Duane Arnold Energy Center Docket No. 50-331 Renewed Facility Operating License No. DPR-49

Supplement to License Amendment Request (TSCR-183): Application to Revise Technical Specifications for the Permanently Defueled Condition

SUPPLEMENT TO LICENSE AMENDMENT REQUEST (TSCR-183)

Figure 3.1.7-1 (page 1-of-1)
Sodium Pontaborate Solution Volume
Versus Concentration Requirements

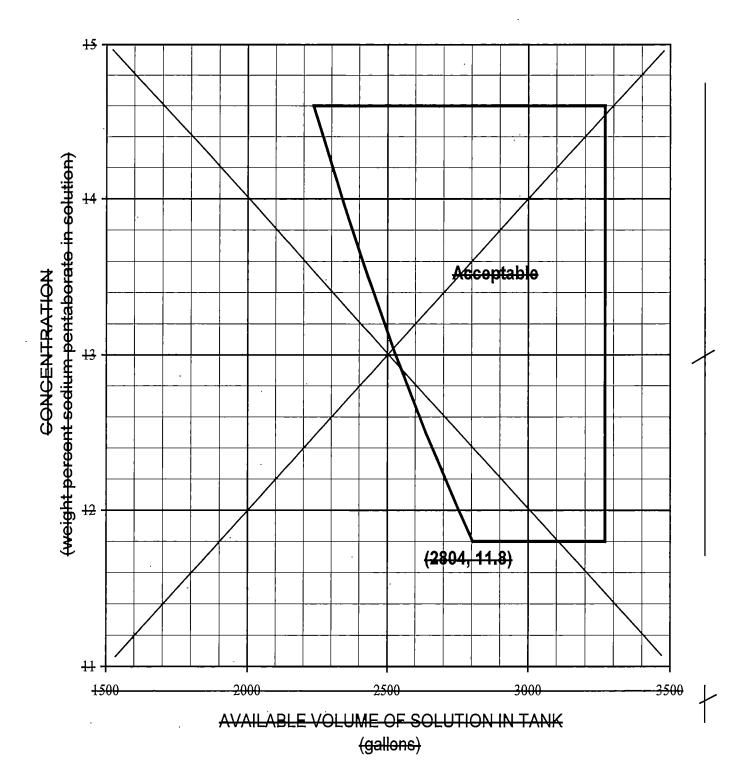
SURVEILLANCE	FREQUENCY
<del>SR 3.1.7.6</del>	Verify each pump develops a flow rate ≥ 26.2 gpm at a discharge pressure ≥ 1150 psig.	In accordance with the INSERVICE TESTING PROGRAM
<del>SR-3.1.7.7</del>	Verify flow through one SLC subsystem from pump into reactor pressure vessel.	In accordance with the Surveillance Frequency Central Program
SR 3.1.7.8	Verify all heat traced piping between storage tank and pump suction is unblocked.	In accordance with the Surveillance Frequency Control Program  AND  Once within 24 hours after solution temperature is rectored within the limits of Figure 3.1.7 2
